Hunts Point Wastewater Treatment Plant New Anaerobic Digester Facilities

Site Management Plan Addendum

July 2021 | Contract: HP-238-DES | PIN: 82614WP01294

Subject: Site Management Plan Addendum, Barretto Point Site, DEC Site No. B00032-2
Design Services and Design Services During Construction for the New
Anaerobic Digesters at Hunts Point WWTP
Contract: HP-238-DES, Contract Reg. No.: CTC 826 20161412692

Figure 4. Area of soils subject to BUD

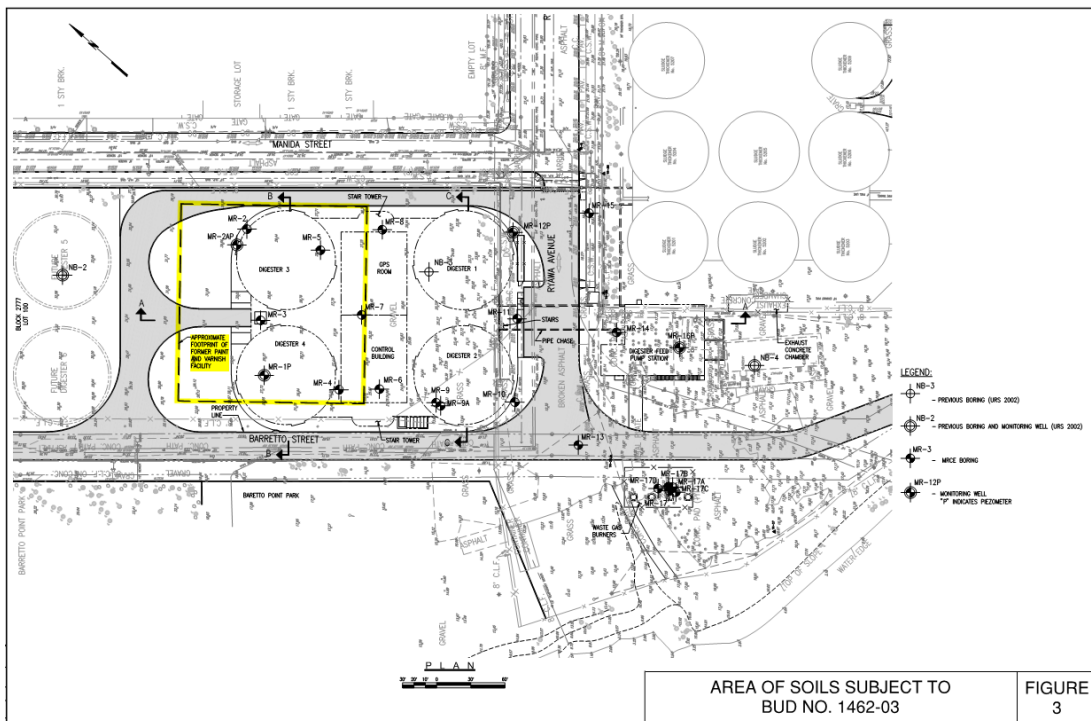
4. Fill material represented by sample MR-9 (Figure 4) may not be reused. The concentration of benzo(a)pyrene in this sample was greater than the Part 375-6 SCO for Commercial Use.

5. The fill material backfill shall be covered with one foot of clean soil and ballast. The clean soil cover shall be General Fill as per Part 360.13(f) and the ballast shall be gravel, rock or stone, consisting of virgin material from a permitted mine or quarry as per NYSDEC DER-10, 5.4(e)5.i. Prior to placement of the one foot of clean soil, a demarcation layer will be installed to identify the top of the reused imported clean fill.

Figure 5. Landscape Layout Plan

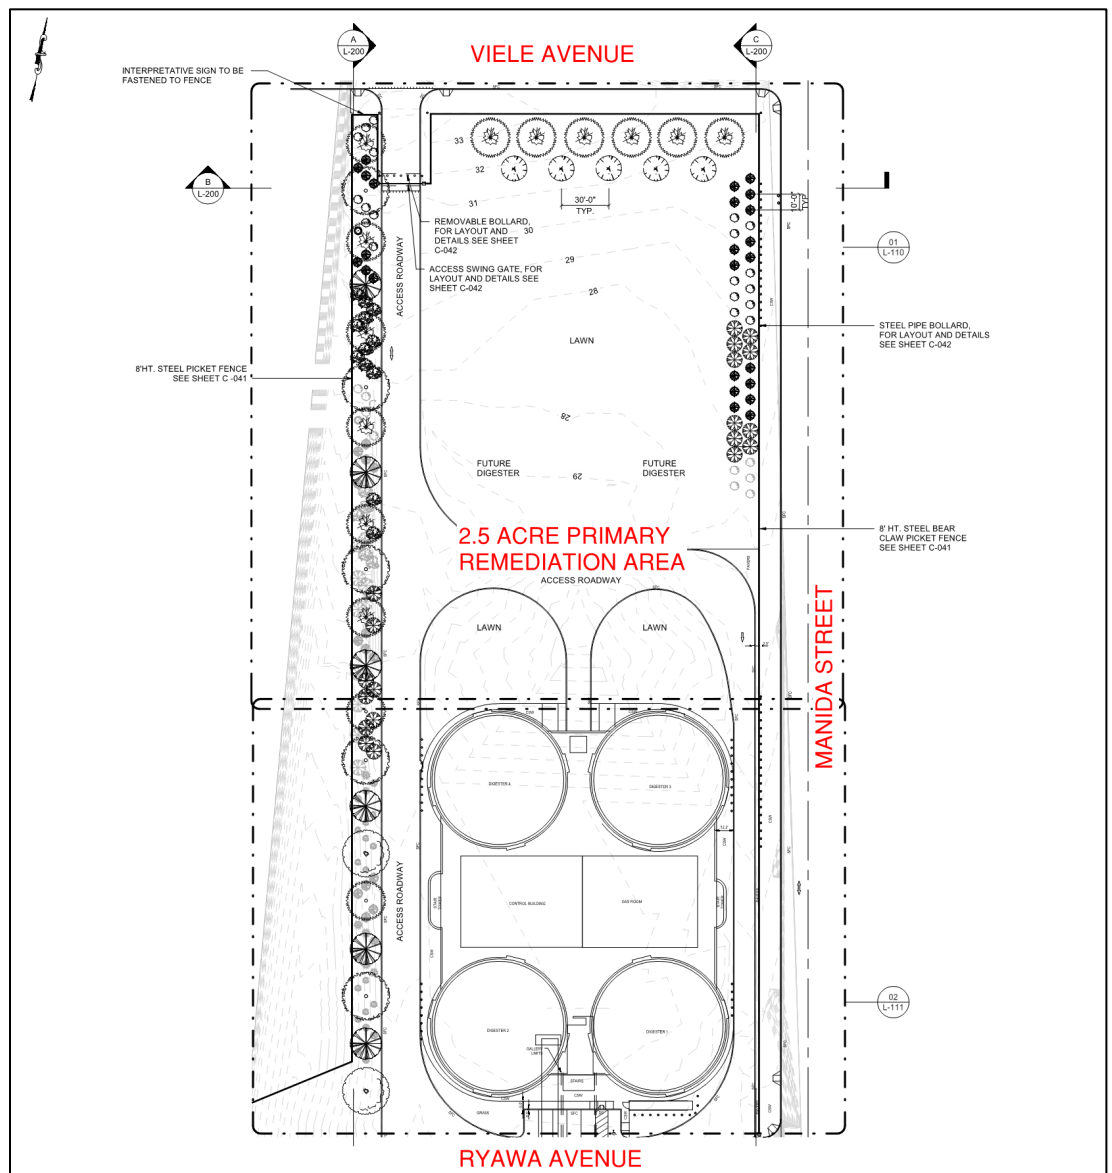
The construction of the new digestion facilities will include landscaping as required by the Final Environmental Impact Statement. The landscaping areas and methods are specified in HP-238 90% Design Landscape Drawings (Attachment B). The landscaping will include planting of trees and shrubs along the west, north and east sides of the 2.5 acre Primary Remediation Area (Figure 5). As shown on Drawing I-700 in Appendix C, the planting areas will vary in size depending on the variety of the particular plant, the size of the root ball, plant spacings, etc. If plantings are closely spaced, an area may encompass more than a single plant.

Trees and shrubs will be planted by excavating the six inch layer of crushed stone and up to 18 inches of the underlying clean fill that were installed during remediation of the Barretto Point Site. The crushed stone and clean fill will be segregated and stockpiled for on-site reuse in accordance with the SMP. At each planting location, the exposed portion of the original demarcation layer will be cut, removed and properly disposed of. The underlying, potentially contaminated soil, may be de-compacted as needed by roto-tilling, disking or ripping to a depth of six to eight inches minimum and preferably a depth of 12 inches to 18 inches (Attachment B, Drawing L-001). Except in small planting areas, the roto-tilling, disking or ripping will be conducted in place (i.e., within the excavation). De-compaction of small planter areas may require removal of the compacted soil to a depth of 18 inches or more and then re-installing the soil loosely with required amendments. If soil is removed for decompaction, it will be placed on plastic sheeting or in suitable containers such as a wheelbarrow for mixing with amendments. All removed soil will be returned to the excavation. Care will be taken to avoid spilling soil on the surrounding ground surface. Once de-compaction is completed, each planting location will receive the root ball of the tree or shrub along with imported clean planting media including soil, topsoil and mulch (Appendix C, Drawing L-700). The combined thickness of the imported clean soil/topsoil and any remaining original clean fill will be a minimum of 1 foot. In the planting areas the final clean cap will not include a 6 inch layer of gravel as currently exists elsewhere in the clean cap that was installed in

2009. The requirement for a demarcation layer (e.g., orange snow fencing material or equivalent material) will not apply in holes in which trees or shrubs are to be planted because the demarcation layer may interfere with root growth.

In addition to the area shown on Figure 5, landscaping will also address the 4.3 acre Remaining Site Area of the Barretto Point Site south and west of the 2.5 acre Primary Remediation Area (Attachment B, Drawings C-014 and C-015). As shown on Figure 2, the surface of this area currently consists of existing fill, gravel, asphalt or vegetation. Portions of the 4.3 acre Remaining Site Area will be graded using soil from the 2.5 acre Primary Remediation Area, covered with a demarcation layer and a minimum of 1 foot of imported clean fill and topsoil, and then hydroseeded.
